Fire safety for a family home · early warning and safe exit · Taif / Palm House V7.1

Owner decision 1 Nov 2026 (design review E-08, critical) · the adopted scheme, its verification (§ 5) and the family escape plan (§ 6) · the rules cited; the Saudi 2024 texts are **not verified** here: the designer of record confirms them before the permit set

How the net clear opening is counted

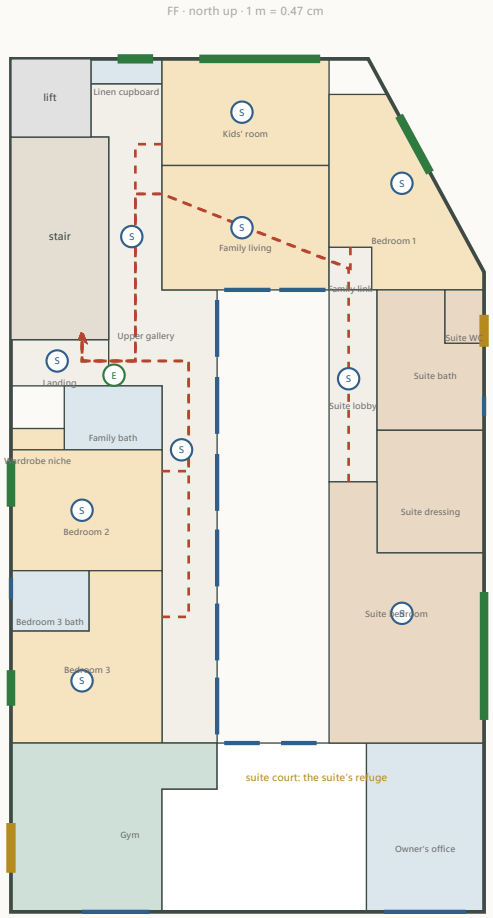
- The window line of the plans is the structural opening; black steel side-hung casements of ≤ 1.2 m, a 50 mm frame and sash edge all round, **one sash opening fully with one movement** (a single handle, no key, no restrictor). Net clear width = sash width − 2 × 0.05 height = (head − sill) − 2 × 0.05. Tilt-only, top-hung or sliding sashes do not count. **Engineer / window supplier to confirm** the sash sizes and the hardware on the shop drawings (**not verified** until then).

- The heights come from `3d/params.yaml` (the maid window listed at sill +1.10; the bedroom windows at the default sill 0.90 / head 2.10). The bedroom windows in the plans are 1.0–3.6 m wide: every one passes with one sash of ≤ 1.0 m, the maid window with its single 1.14 m sash.
